Project: R.077223.220

Rehabilitation of the Lachine Canal walls, Reach 4 – Sectors 14 to 17 Lachine Canal national historic site

Object: ADDENDA # 1

August 15th, 2018

nom du file fichier/ name AD-11

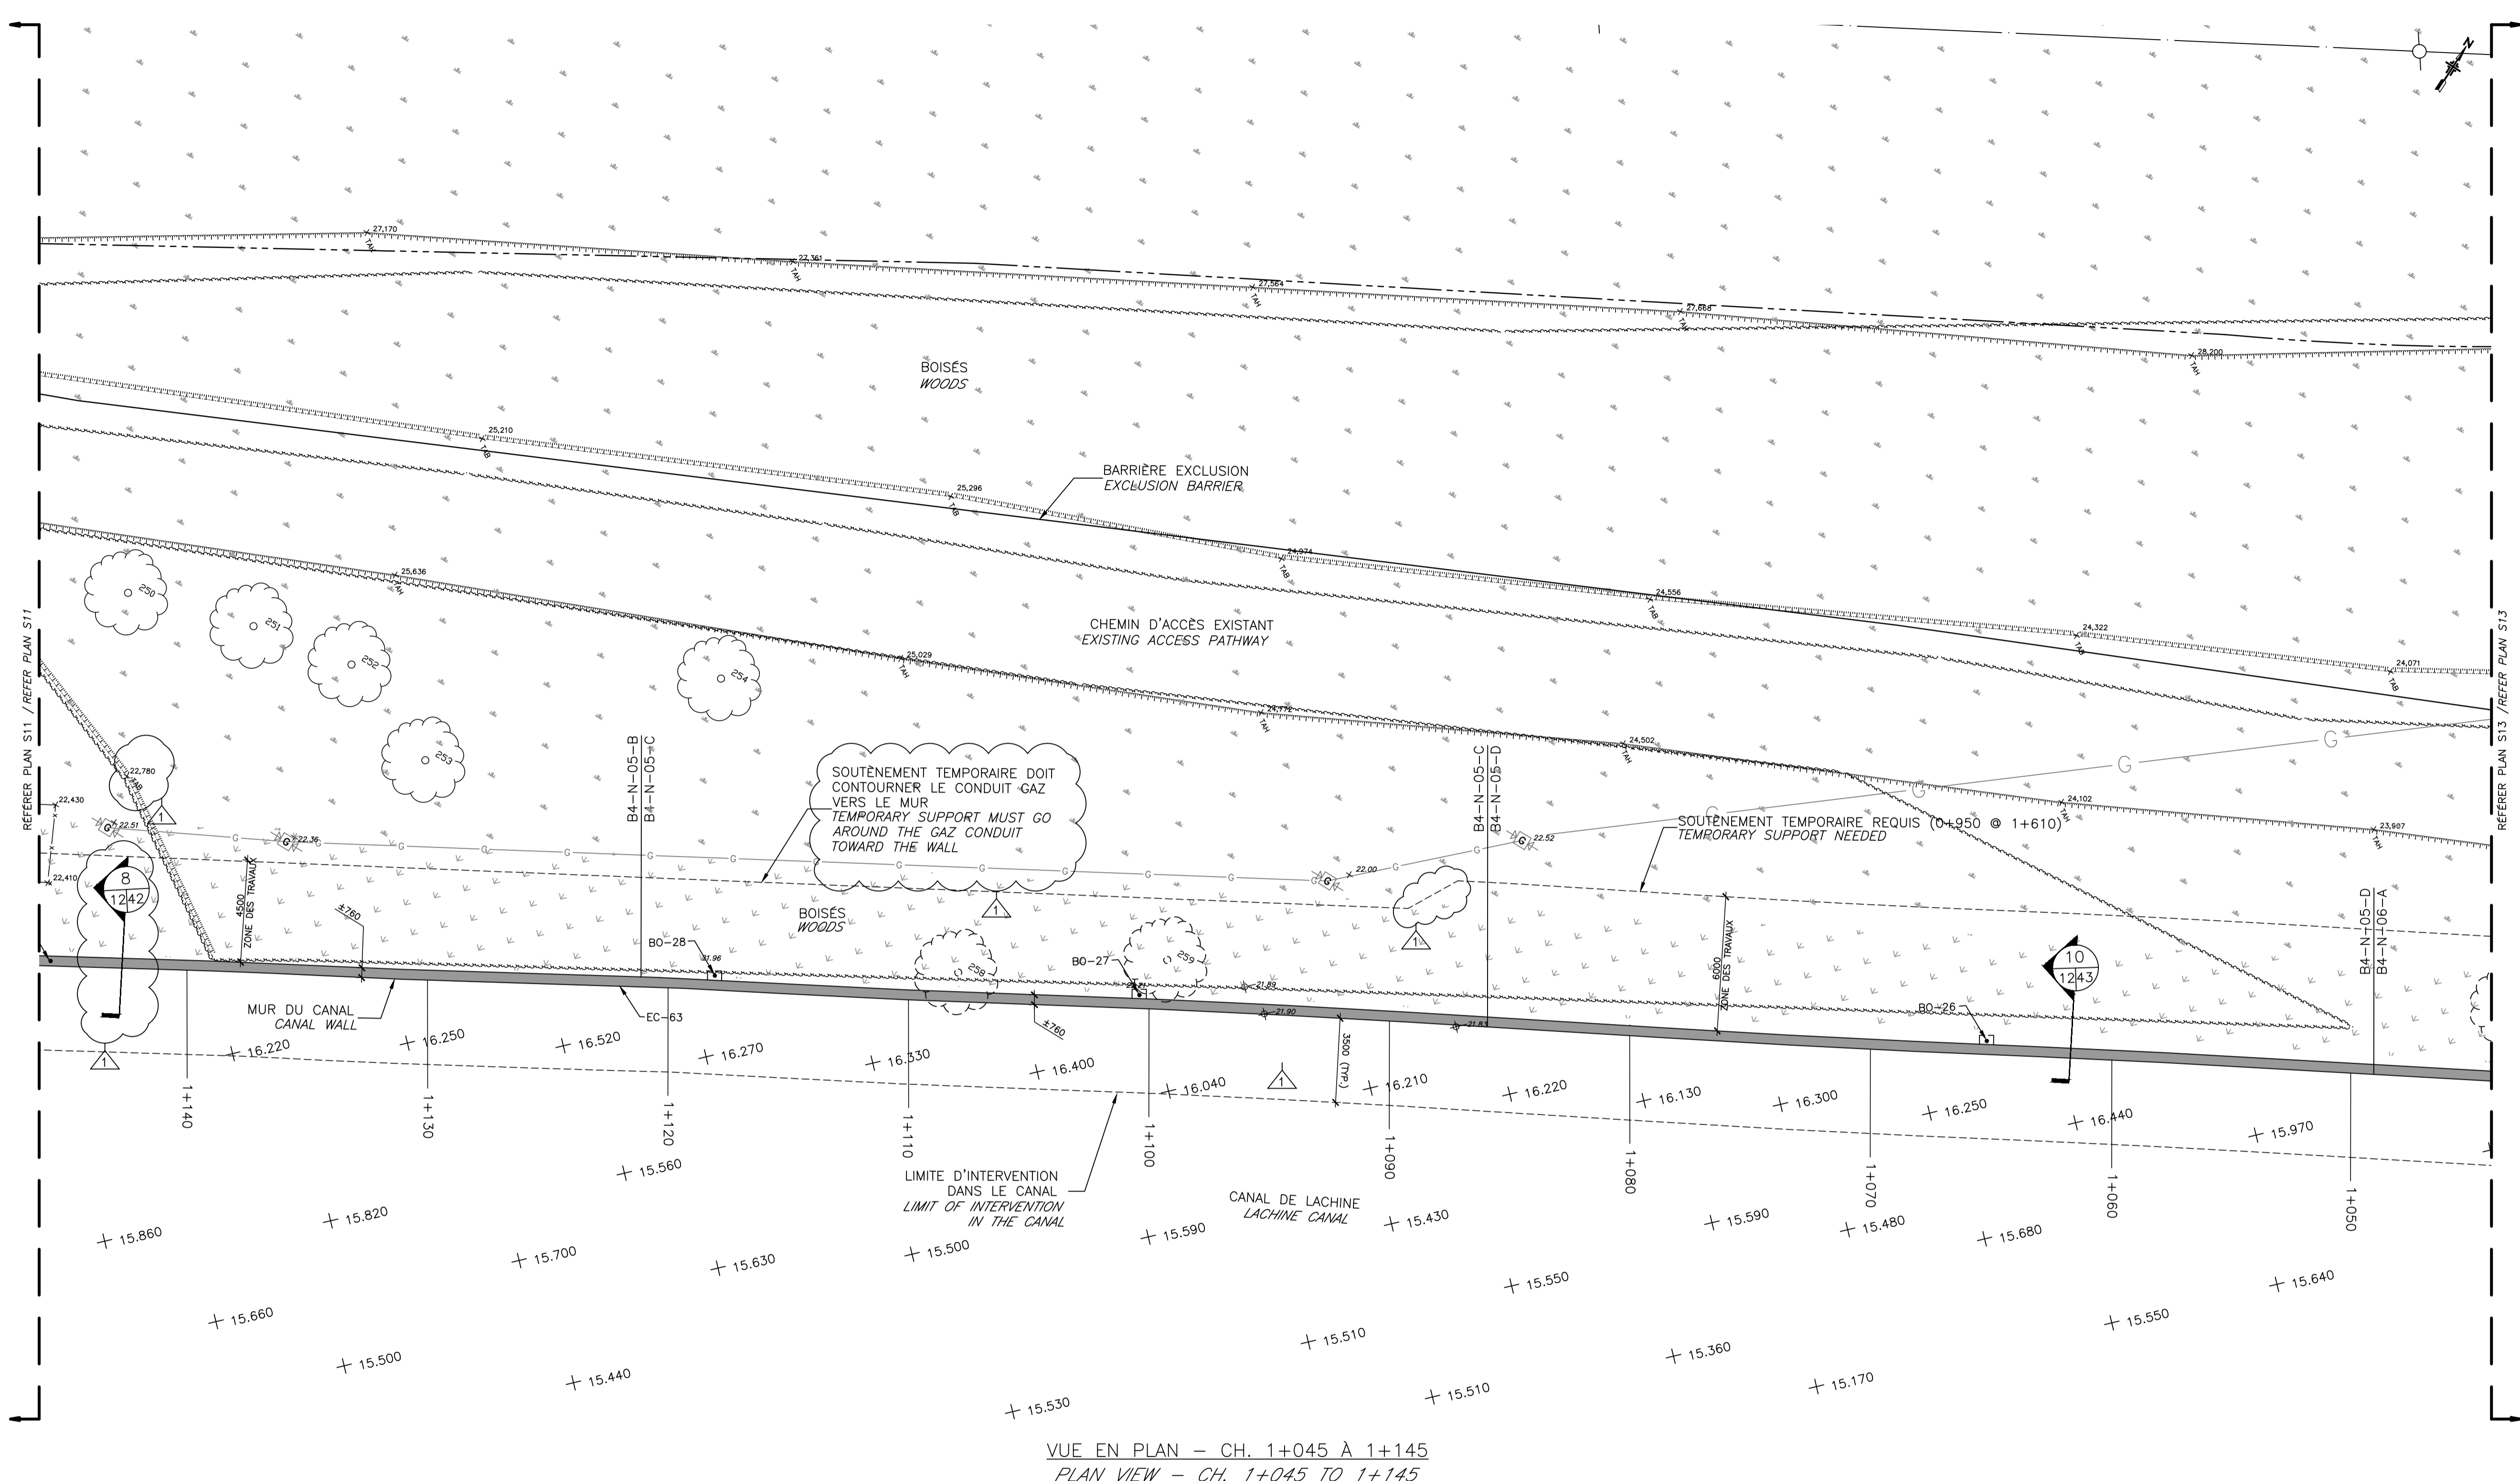
- .1 Modification of the detail W, see AD-11 in the appendix of this document.

nom du file
fichier/ name 1+080

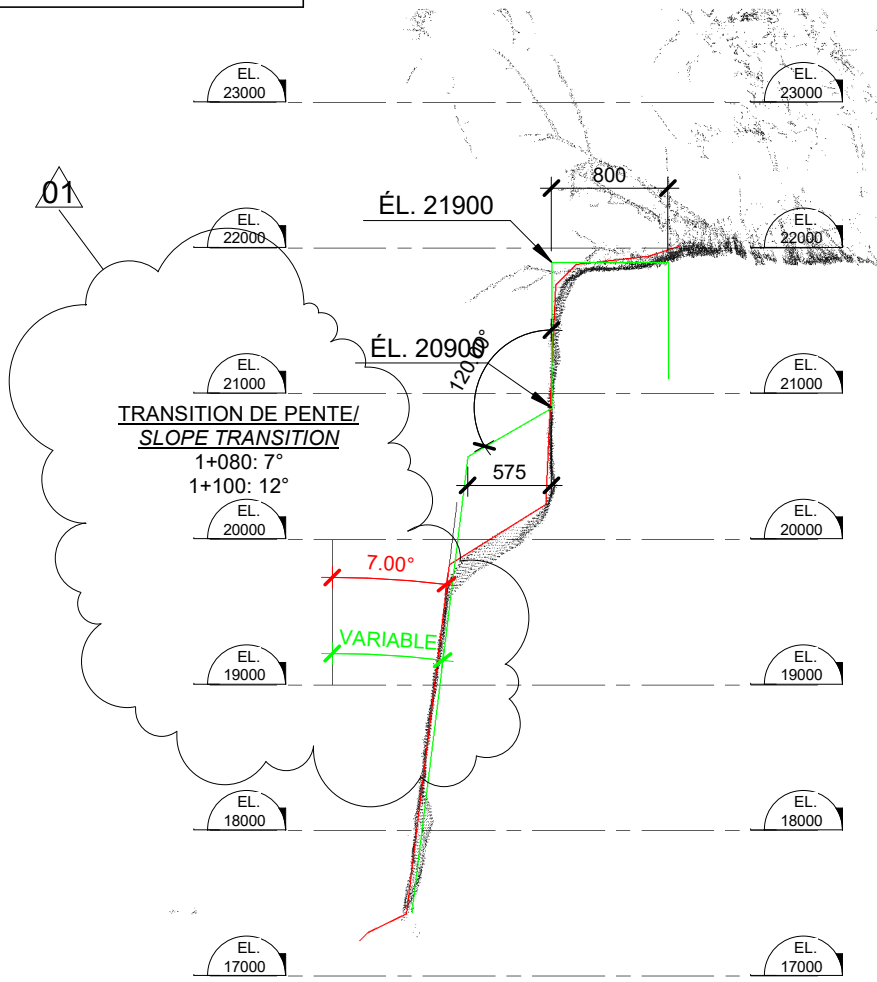
- .1 The following sections have been modified:
- .1 1+080: Change in slope transition has been made, see cross section in appendix of this document.
 - .2 1+090: Change in slope transition has been made, see cross section in appendix of this document.

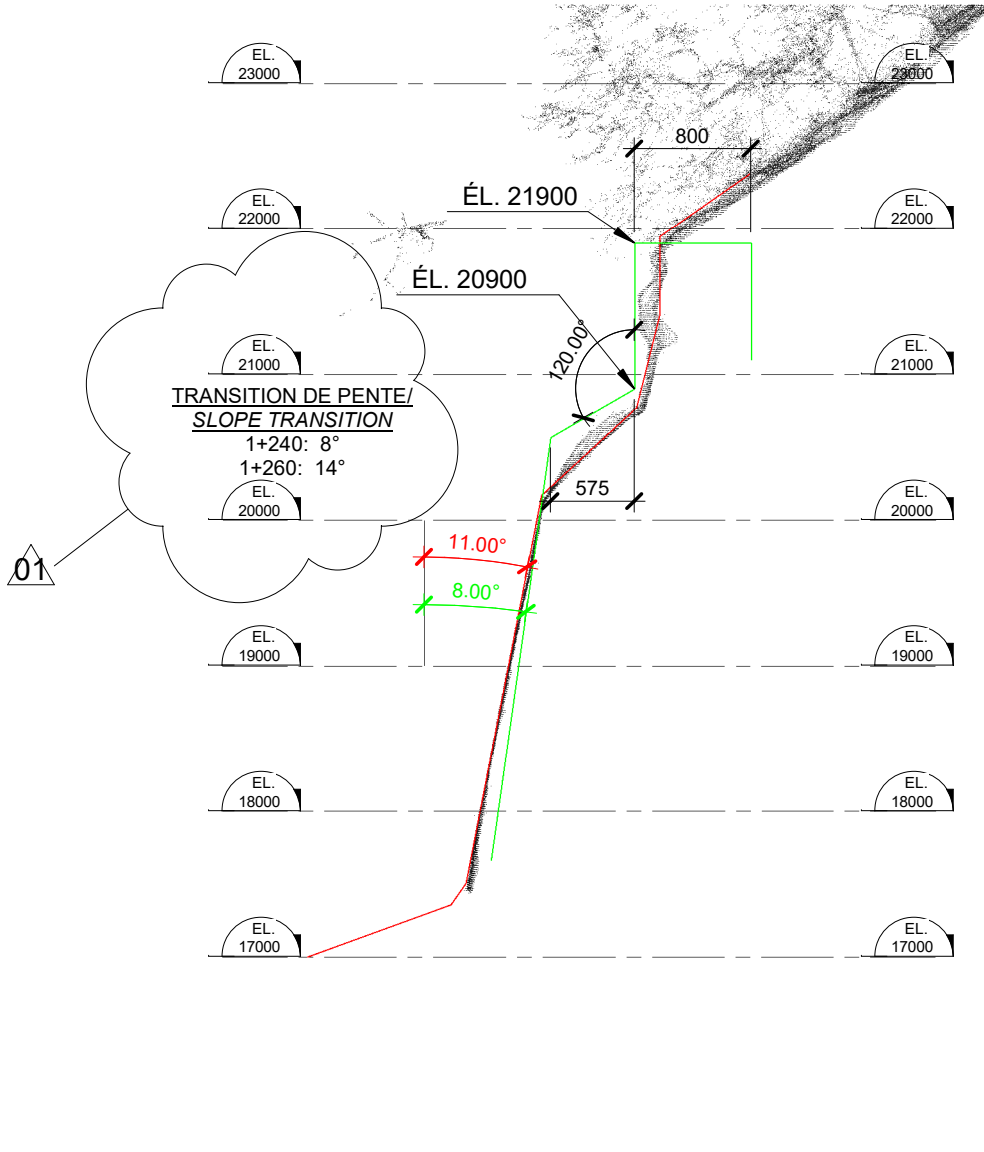
- .3 1+100 : Change in slope transition has been made, see cross section in appendix of this document.
 - .4 1+240: Change in slope transition has been made, see cross section in appendix of this document.

nom du file
fichier/ name 1+250

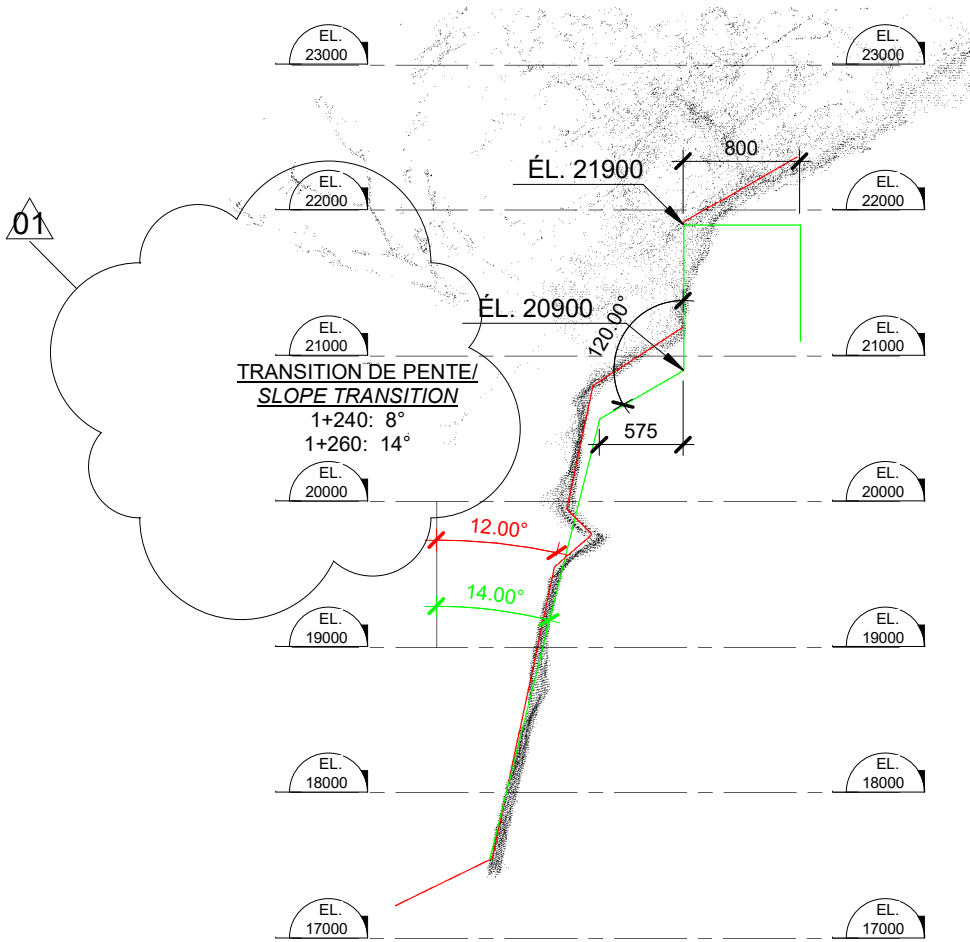
- .5 1+250: Change in slope transition has been made, see cross section in appendix of this document.
 - .6 1+260: Change in slope transition has been made, see cross section in appendix of this document.

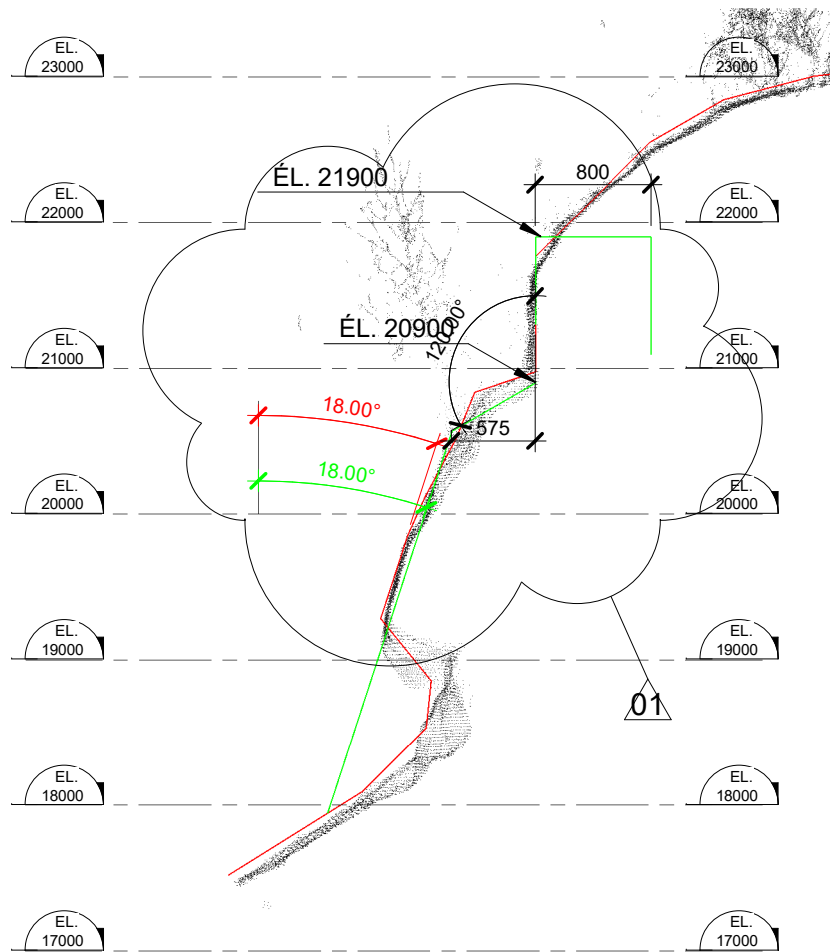
- .7 1+490: Change in proposed slope has been made, see cross section in appendix of this document.
 - .8 1+510: Change in tablet width has been made, see cross section in appendix of this document.

nom du file
fichier/ name 1+580

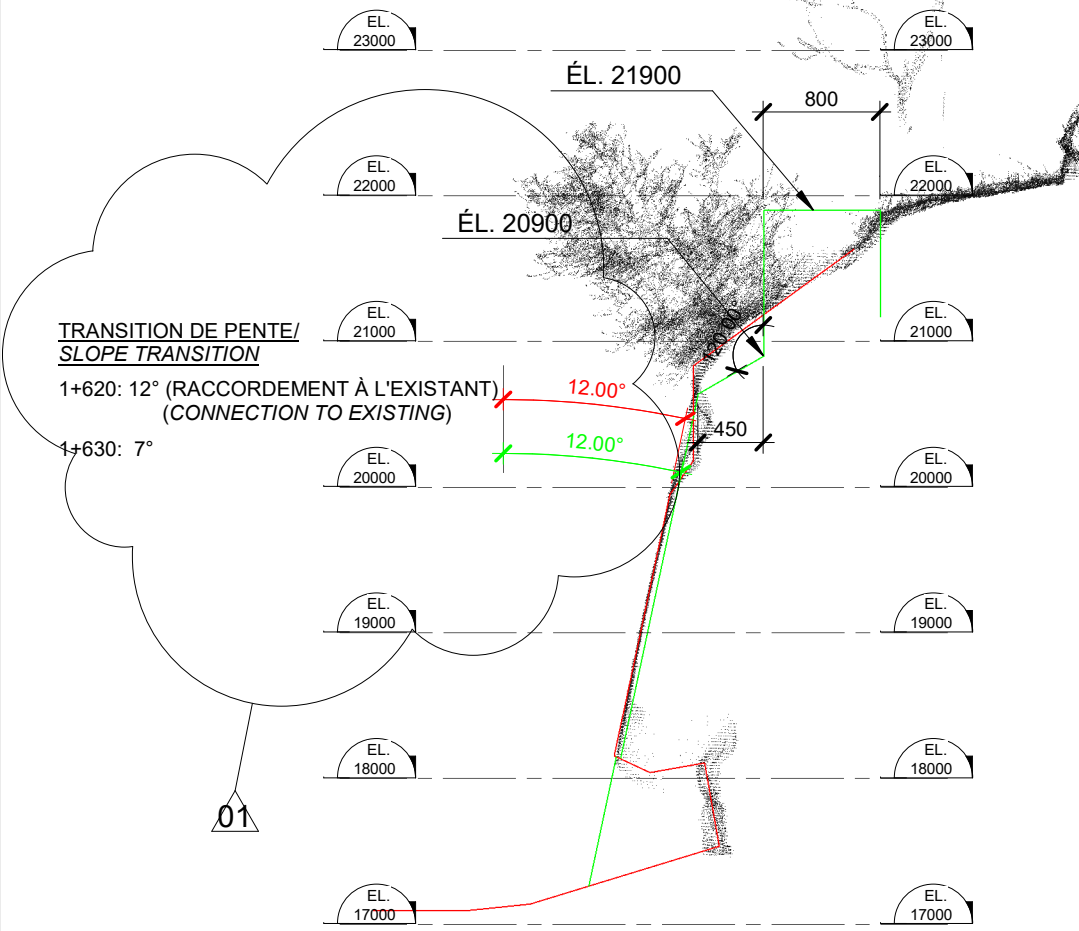
- .9 1+580: The existing connection of the proposed profile has been added, see cross section in the appendix of this document.
 - .10 1+620: Additional information has been added to the slope transition note, see cross section in the appendix of this document.
